1 **EXHIBIT 2 – RATE BASE**

3 **Response to Ontario Energy Board Staff Interrogatory 2-Staff-18**

2005-2014 No. of Planned Outages Required for Operating Oil Switch

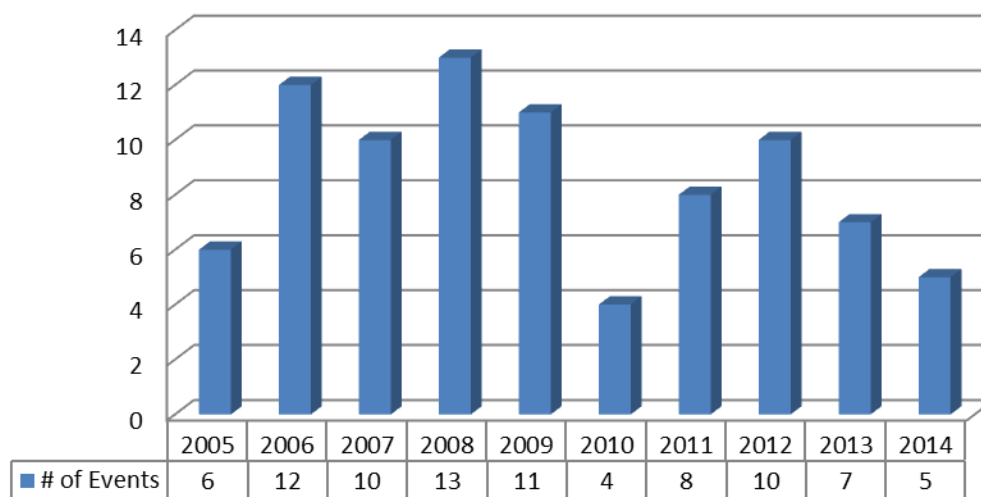
- 15 a) Is it anticipated that replacement of the aging oil switches will eliminate or
16 significantly reduce Outage Code 1B outages?
- 17 b) What is the count of problematic/unsafe oil switches in the Kingston Hydro system
18 at present?
- 19 c) How many problematic/unsafe oil switches will remain in the Kingston Hydro
20 system after 2020 following the planned replacements under the DSP?

- 24 a) It is anticipated that the continued replacement of the aging oil switches will
25 reduce Outage Code 1B outages. Kingston Hydro replaced five oil switches (21
26 switched ways) during the last rate application period (2010-2014) and plans to
27 replace 4 switches (16 switched ways) in the next five years. The table below
28 shows the trend of the planned outages required for operating oil switches

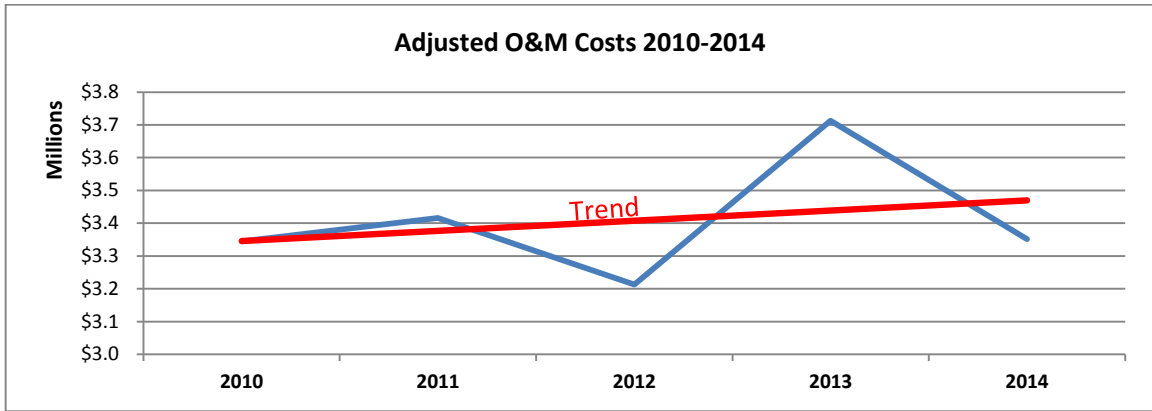
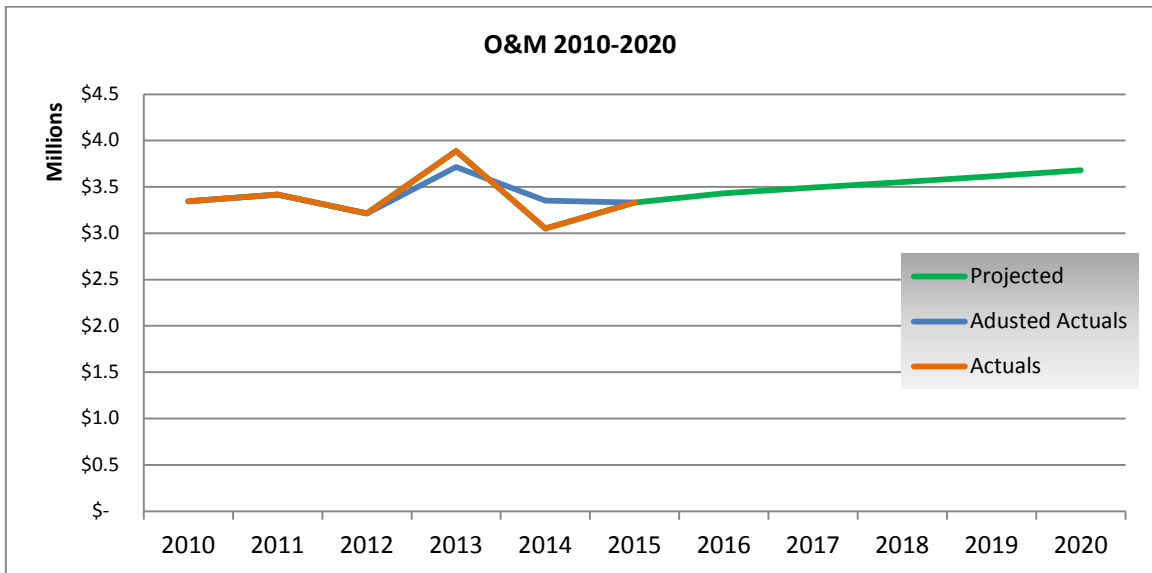
20 b) Given the forecast increase in average expenditures for System Renewal and
21 System Service projects, and considering the planned General Plant
22 expenditures on upgraded CIS, GIS and Financial systems, should the
23 expectation not be that O&M costs will decrease over the forecast period?

51 The Applicant would argue that this represents a more fair representation. As
52 the graph below illustrates, the trend actually indicates cost increases, not cost
53 reductions.

The graph below puts all of this in context with the proposed O&M costs.
